Staff Hydrogeologic Review, Findings, and Recommendations for Operating Permit Applications

OP III ATX Ledgestone II, LP; OP III ATX Ledgestone I, LP; OP III ATX Ledgestone I TH, LP

Lane Cockrell, General Manager / Hydrogeologist
Southwestern Travis County Groundwater Conservation District

April 17, 2026

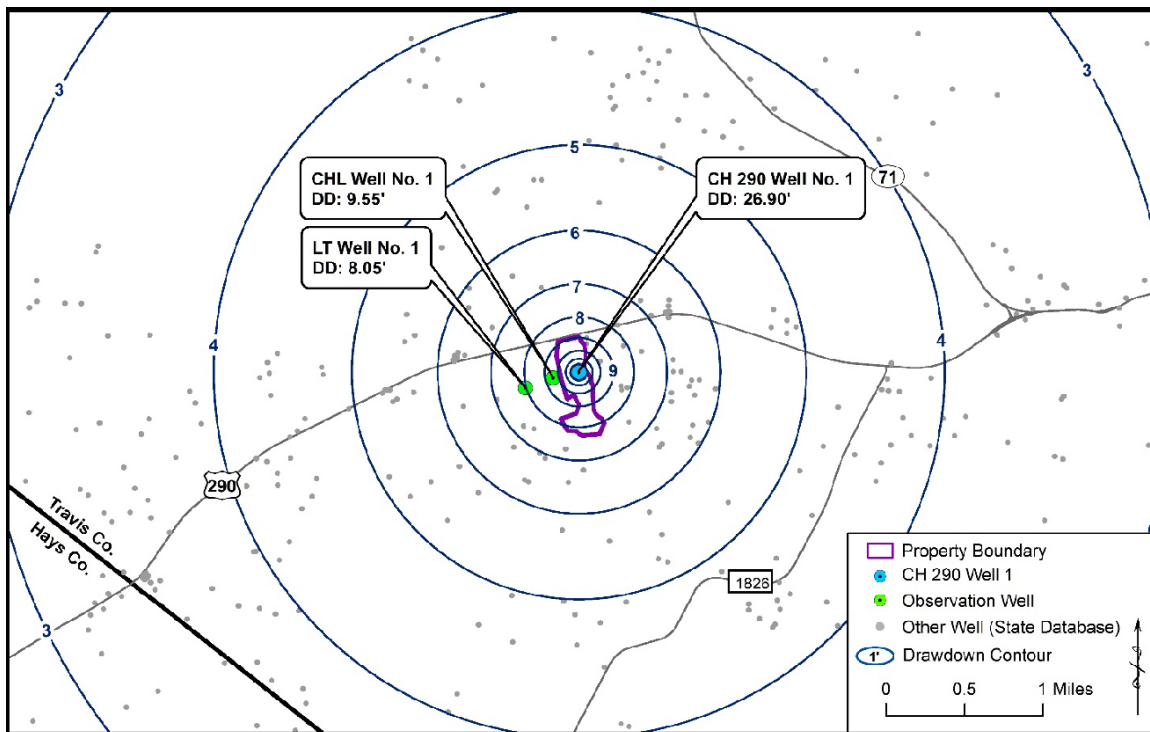
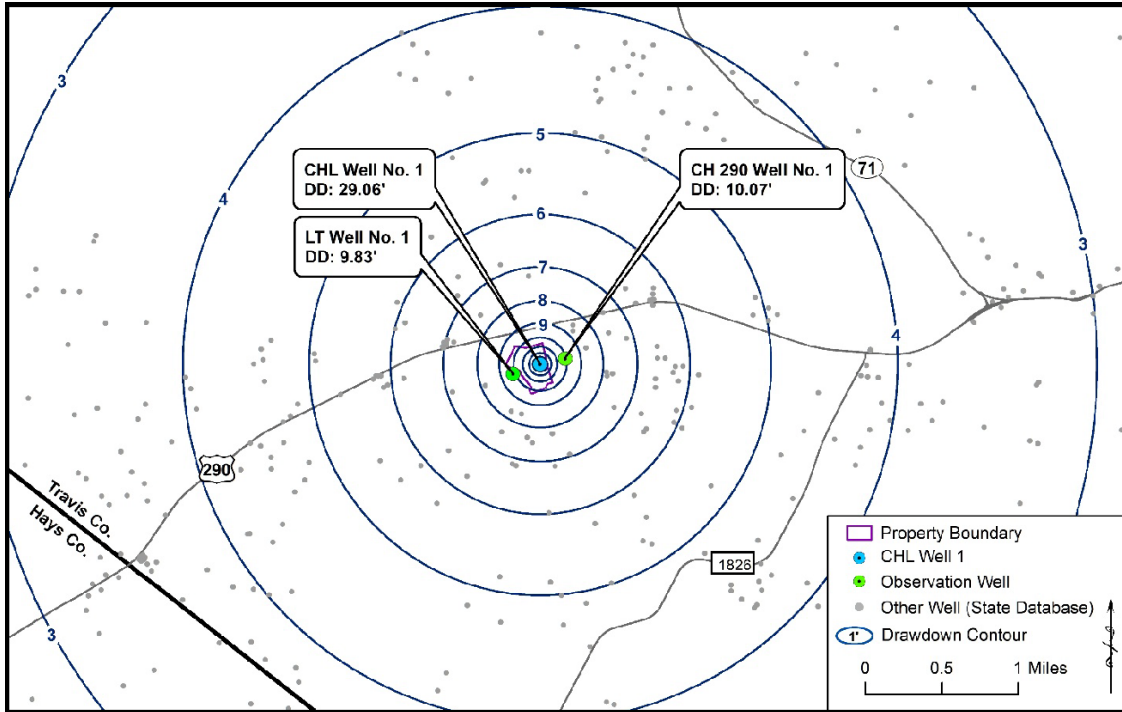
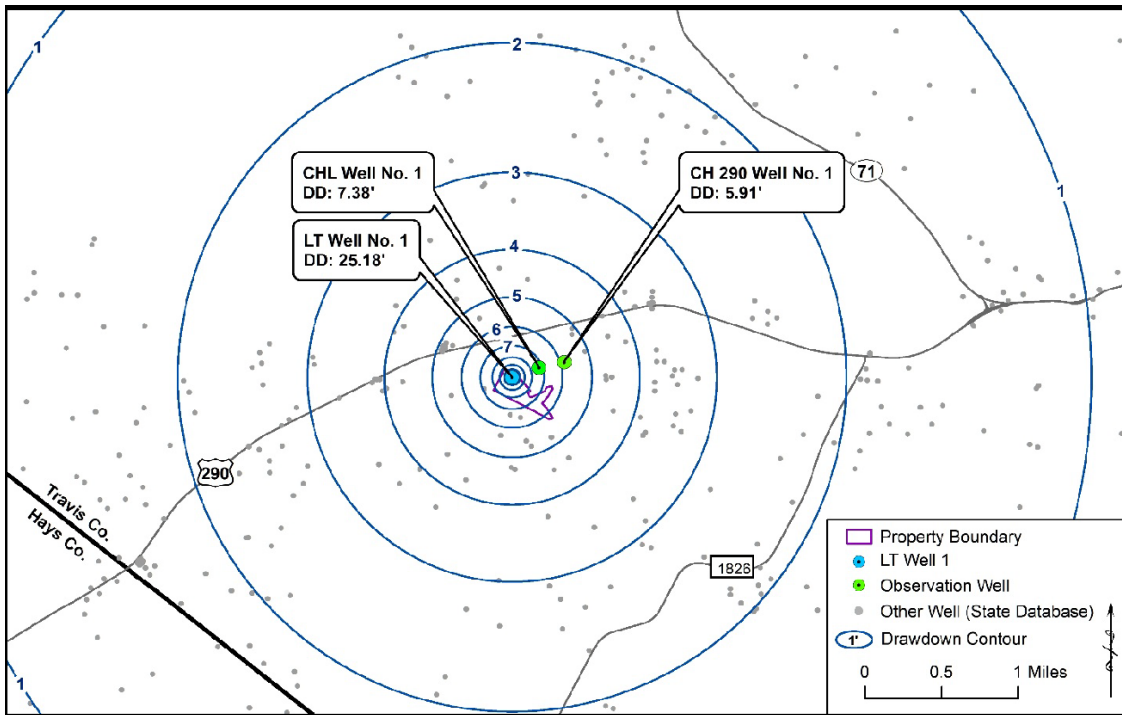
Analytical modeling presented in the hydrogeologic reports submitted with each application indicates that pumping from each proposed well at the requested production

volumes would likely cause localized drawdown extending several miles from each pumping center. Estimated drawdown after 7 years of individual-well pumping is summarized in **Table 3** and shown in **Figures 2 through 4**.

Application	At Well	1 Mile	2 Miles	3 Miles	Figure
OP III ATX Ledgestone II, LP	27 feet	6 feet	4.5 feet	3.5 feet	Figure 2
OP III ATX Ledgestone I, LP	29 feet	6 feet	4.5 feet	3.5 feet	Figure 3
OP III ATX Ledgestone I TH, LP	25 feet	3.5 feet	2 feet	1.5 feet	Figure 4

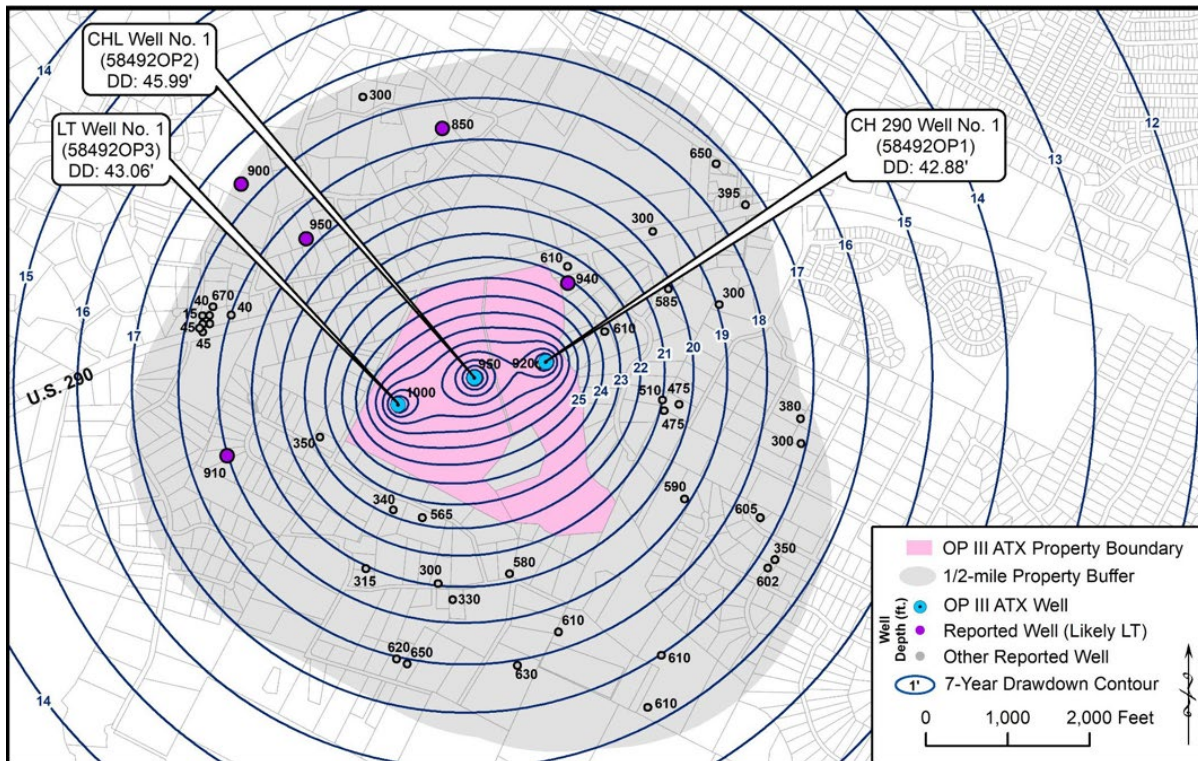
Analytical modeling also indicates that combined pumping from the three proposed wells at the requested annual production volumes would likely cause significant localized drawdown and interference among the proposed wells and nearby Lower Trinity wells. After 7 years of combined pumping, drawdown at the proposed wells is projected to exceed 40 feet, and drawdown at nearby Lower Trinity wells within an approximately half-mile radius is projected to range from 17 to 23 feet (**Figure 5**).

These modeled drawdown estimates reflect the projected effects of pumping by the proposed LedgeStone wells only and do not account for additional drawdown that may result from pumping by other nearby wells, ongoing regional groundwater-level declines, drought conditions, or future changes in groundwater demand.

Figure 6. Water levels, in feet above mean sea level (ftMSL), over time for Lower Trinity Aquifer wells in the project area and surrounding vicinity. Data sources: TWDB Groundwater Database, Submitted Drillers Report Database, and District groundwater monitoring network.

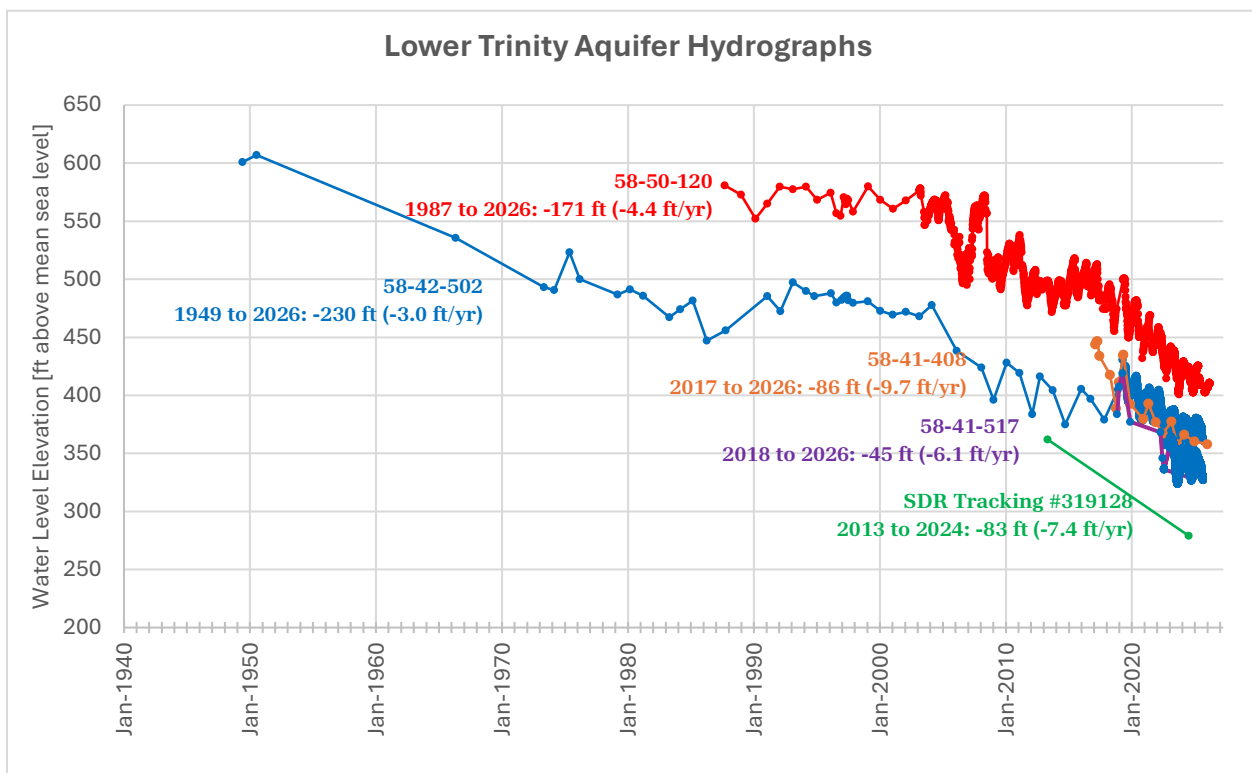
Water-level data from District monitoring wells, the Texas Water Development Board Groundwater Database (GWDB), and the Submitted Drillers Report (SDR) Database indicate prolonged declines in portions of the Lower Trinity Aquifer east of the Bee Creek Fault, including the project vicinity (Hunt et al., 2020)(**Figure 6**). Observed conditions include:

- average annual declines ranging from approximately 3 to 10 feet per year based on available water-level data from Lower Trinity wells in the area (**Figure 6**);

- average long-term declines of approximately 4 feet per year in State Well Numbers 58-50-120 and 58-42-502, which have records extending to the 1980s and 1940s, respectively (**Figure 6**);
- more recent declines during approximately the last 20 years ranging from about 6 to 10 feet per year based on available water-level data from Lower Trinity wells in the area (**Figure 6**); and
- seasonal fluctuations exceeding 40 feet in State Well Numbers 58-50-120, 58-42-502, and 58-41-517, which have measurement frequencies sufficient to characterize seasonal fluctuations (**Figure 6**).

Notably, the static water level in nearby State Well Number 58-50-120, located approximately 3 miles east of the project area, has declined substantially. From October 1987 to March 2026, the measured water level declined from 580.7 feet above mean sea level (ftMSL) to 410.0 ftMSL, a total decline of approximately 170 feet. This corresponds to an average annual decline of approximately 4.4 feet per year (**Figure 6**). Since the 2008 DFC baseline year, declines have accelerated. From May 2008 to March 2026, the measured water level declined by approximately 160 feet, equivalent to an average decline of about 9 feet per year.

These data, along with findings from Hunt et al. (2020), indicate that groundwater withdrawals in this area exceed rates of recharge or recovery and that the aquifer is undergoing depletion, commonly described as groundwater mining. Continued groundwater
